UNITED STATES
NUCLEAR REGULATORY COMMISSION
WASHINGTON, D. C. 20555

R. E. GINNA NUCLEAR POWER PLANT

AMENDMENT TO PROVISIONAL OPERATING LICENSE

Amendment No. 63
License No. DPR-18

Figure 6.2-1

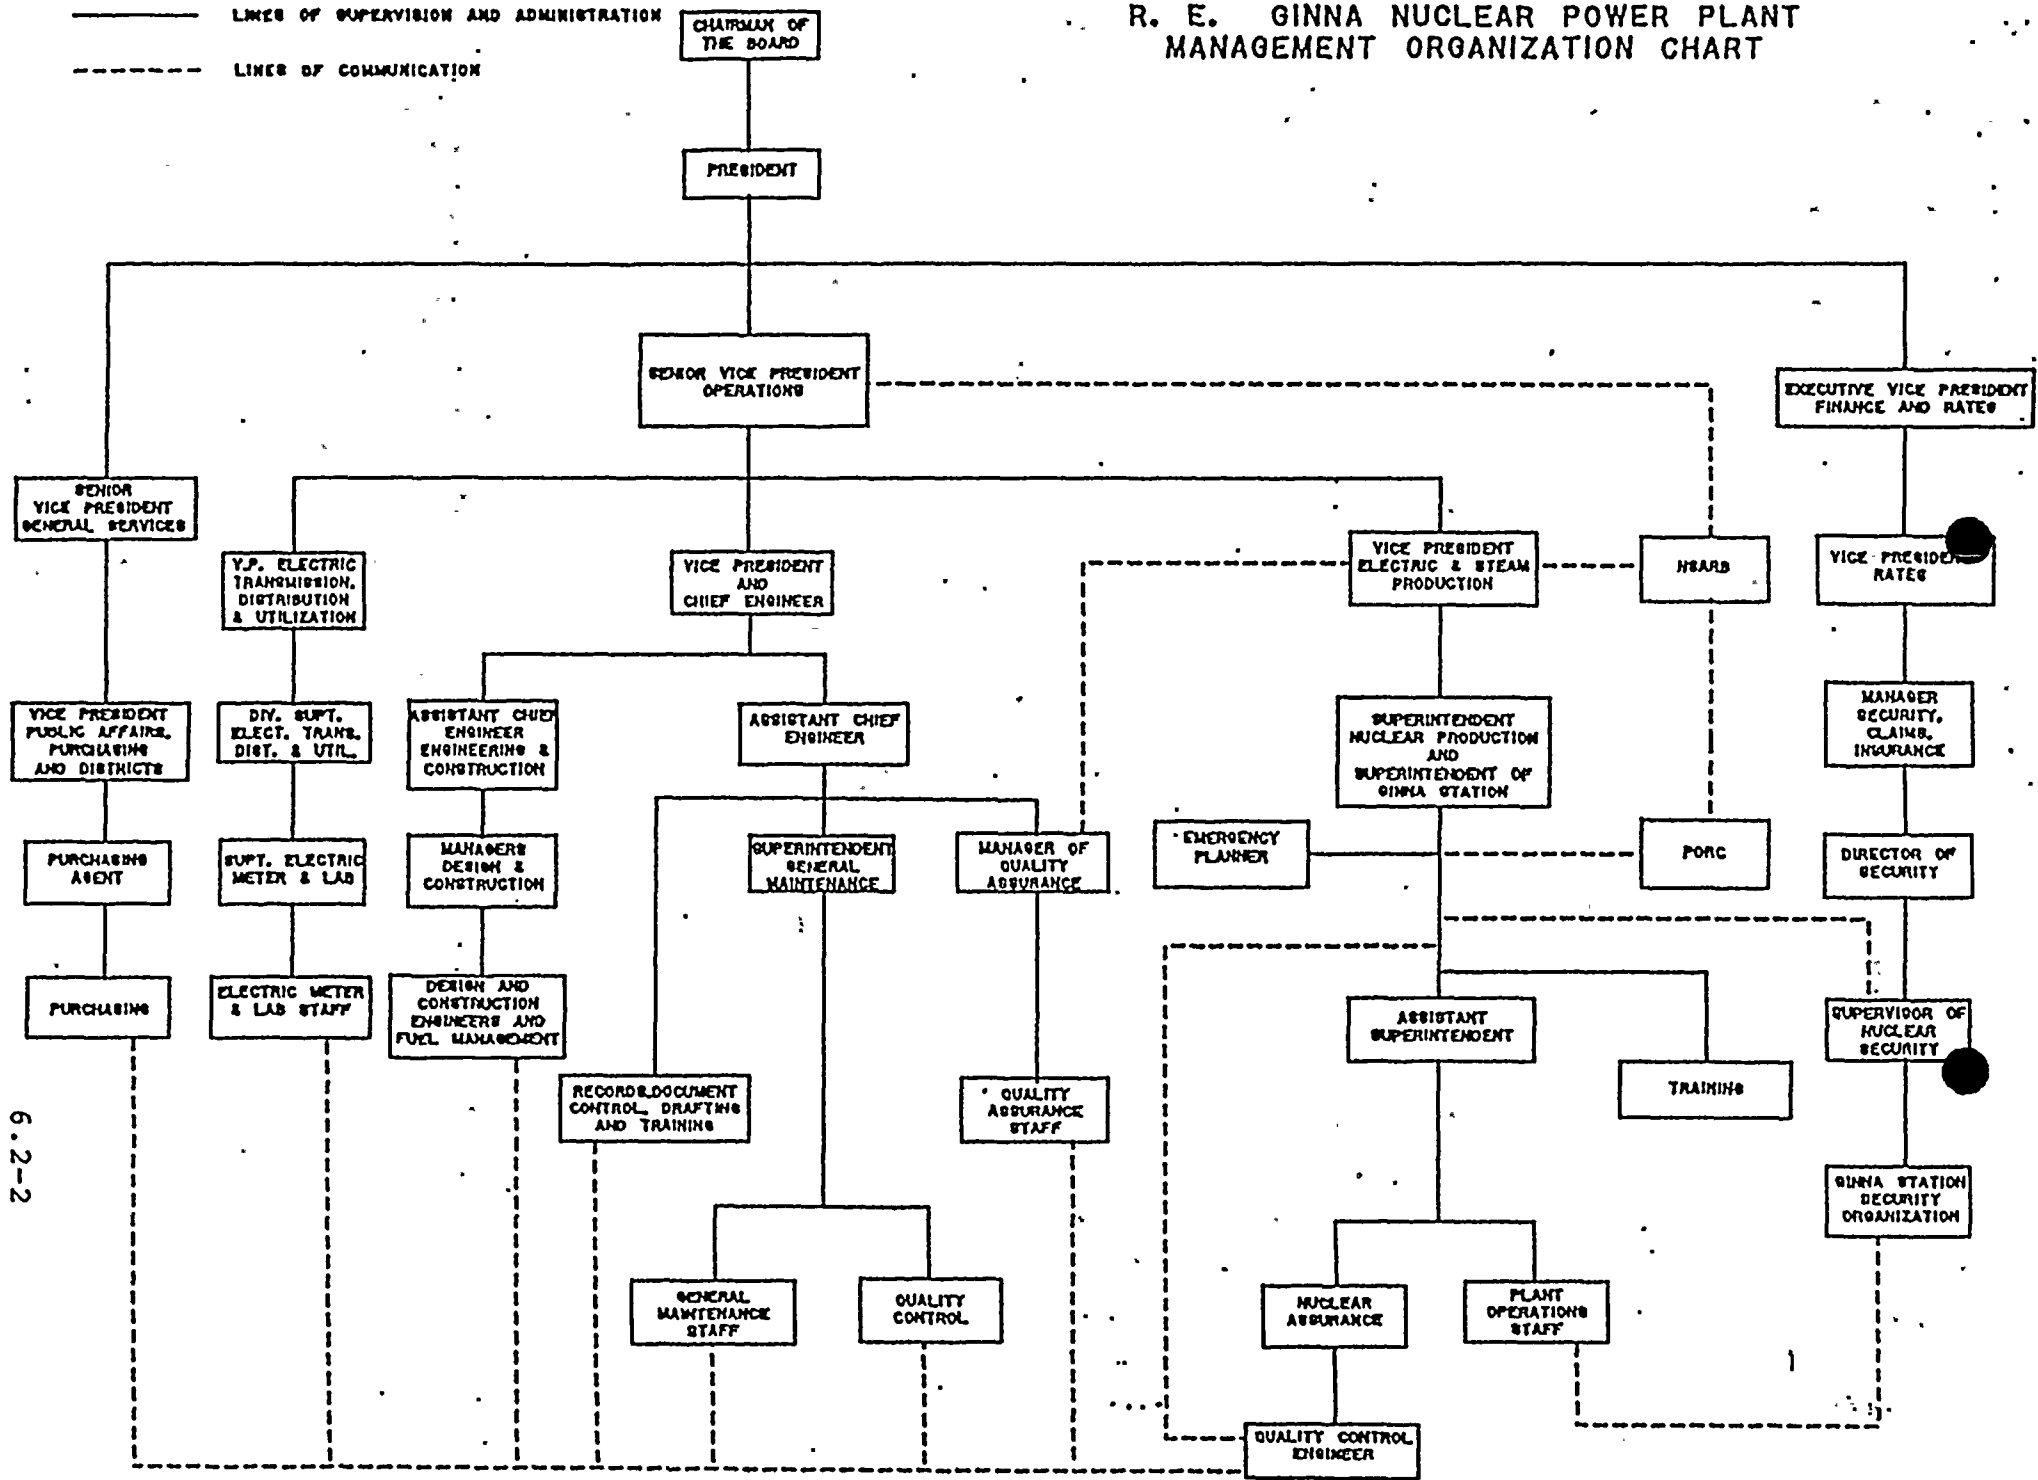
Revise Appendix A Technical Specifications by removing the pages identified below and inserting the enclosed pages. The revised pages contain the captioned amendment number and marginal lines which indicate the area of changes.
